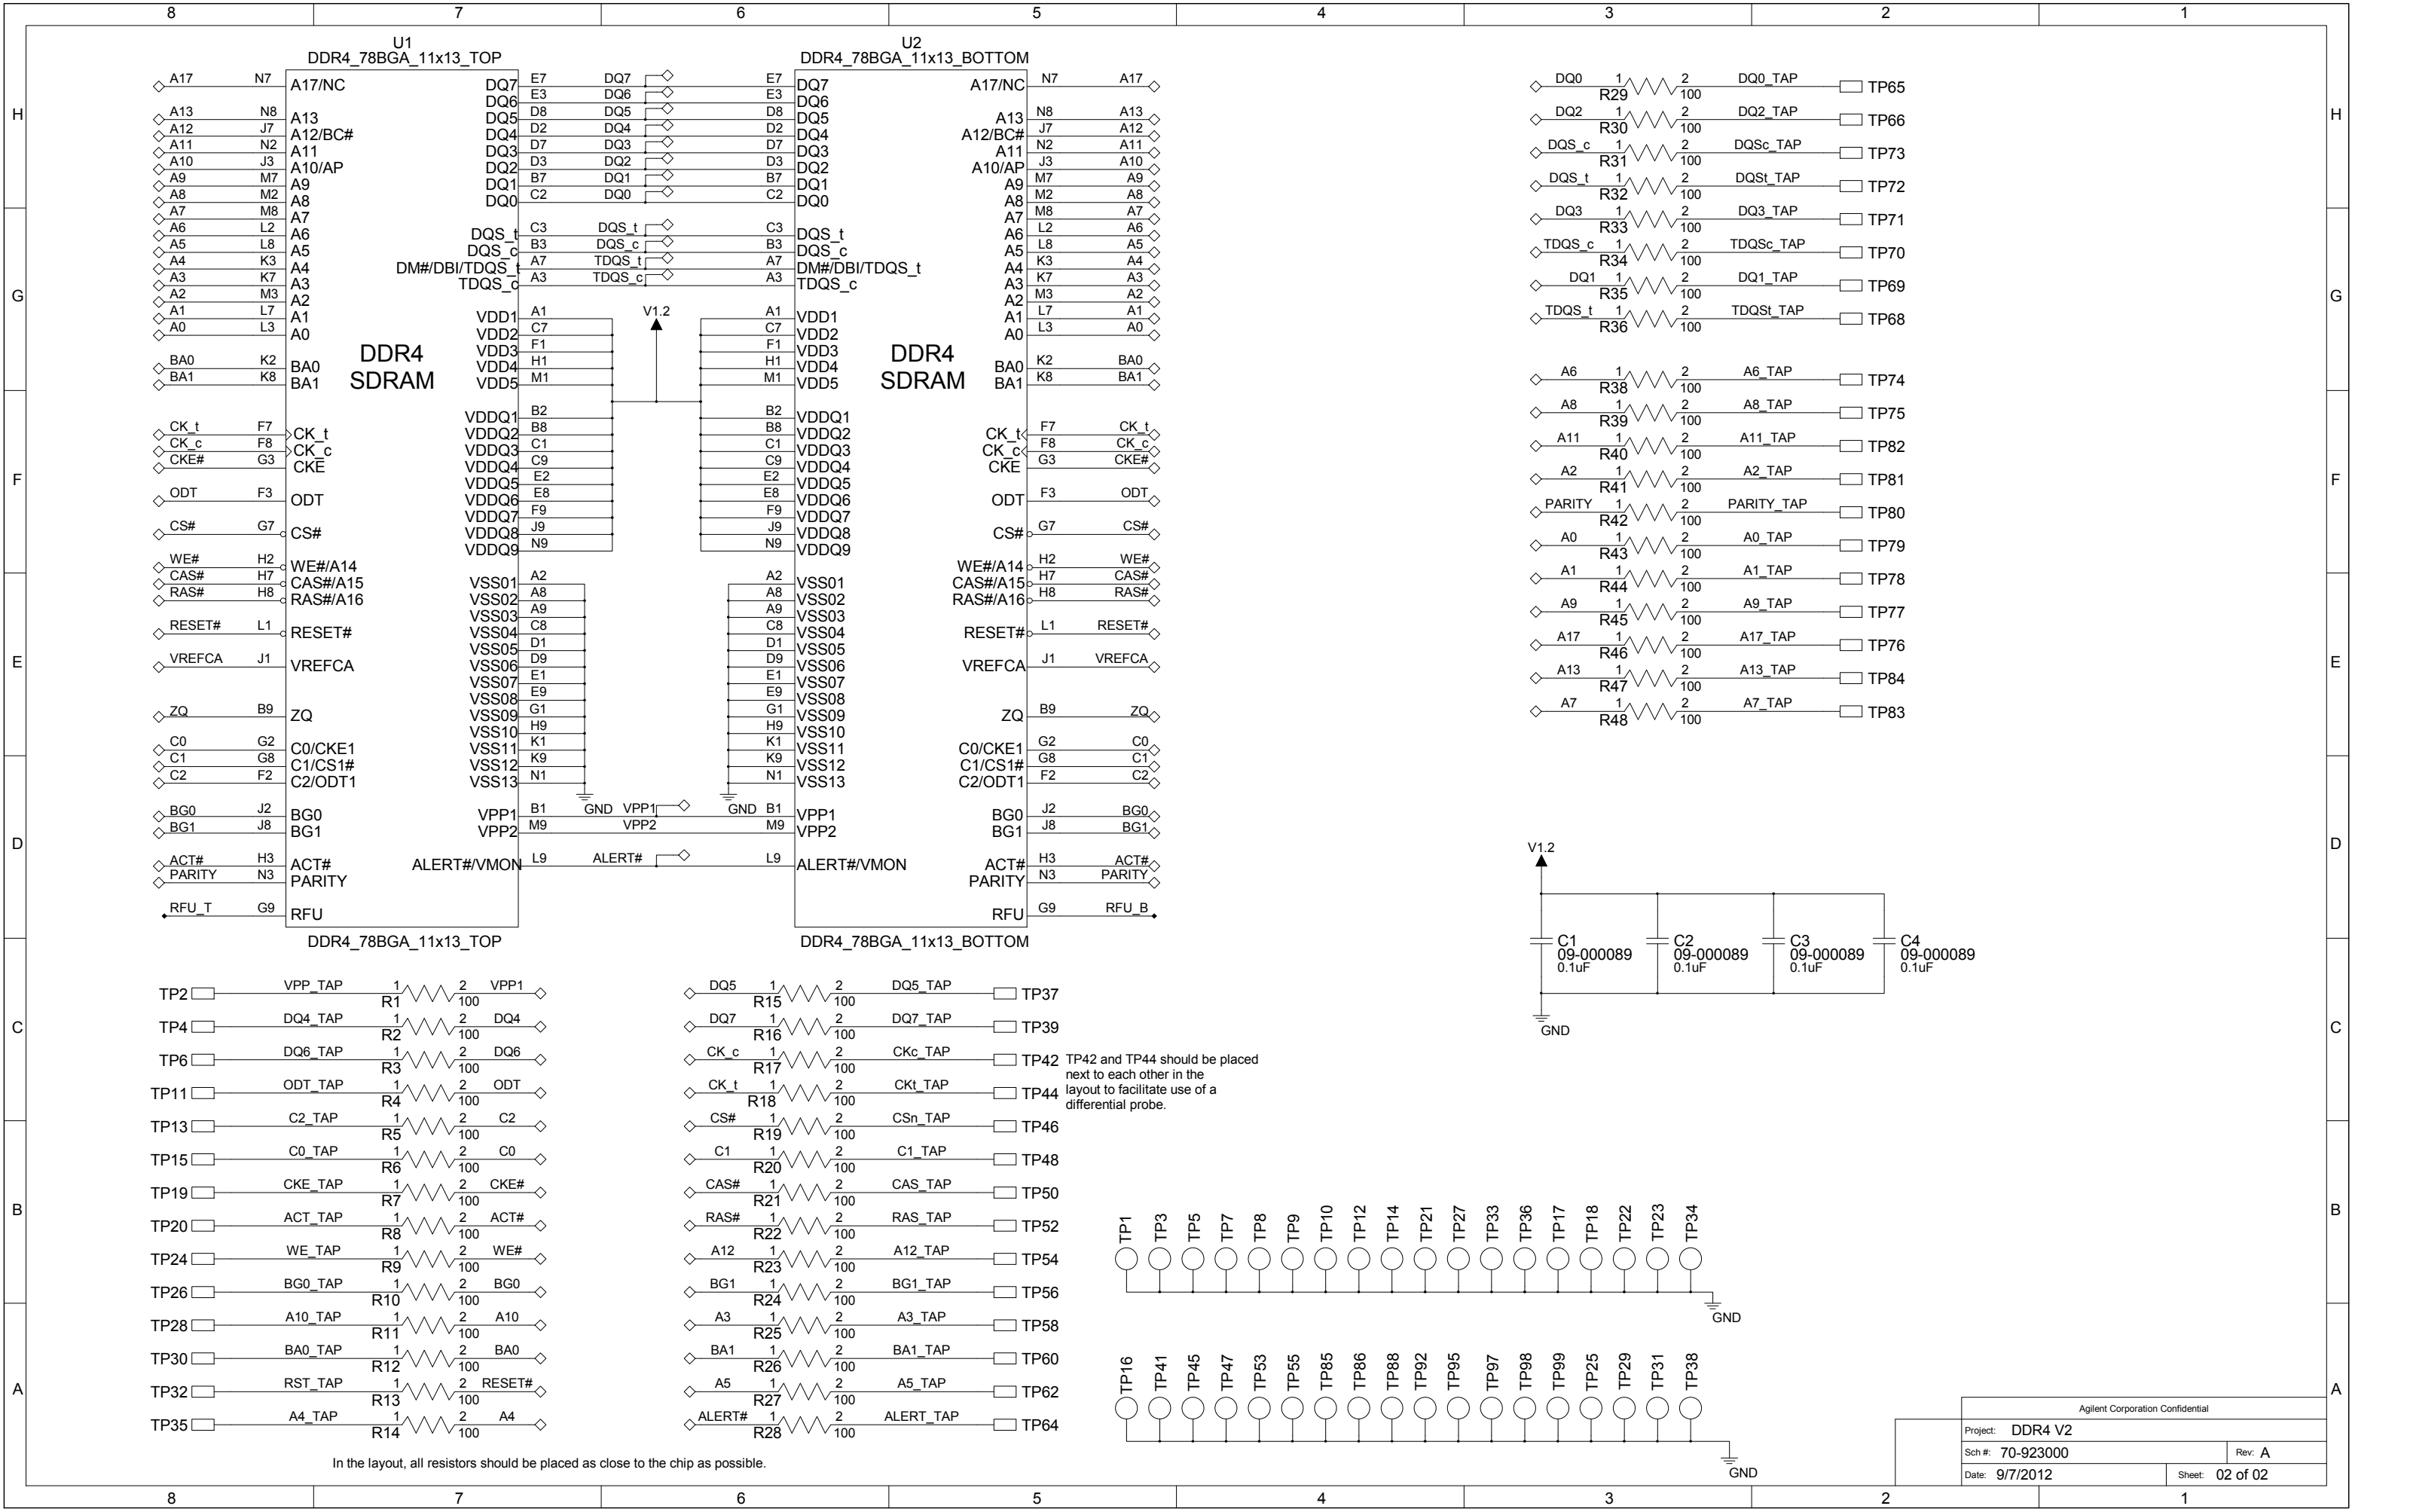
TP42 and TP44 should be placed next to each other in the layout to facilitate use of a differential probe.

In the layout, all resistors should be placed as close to the chip as possible.
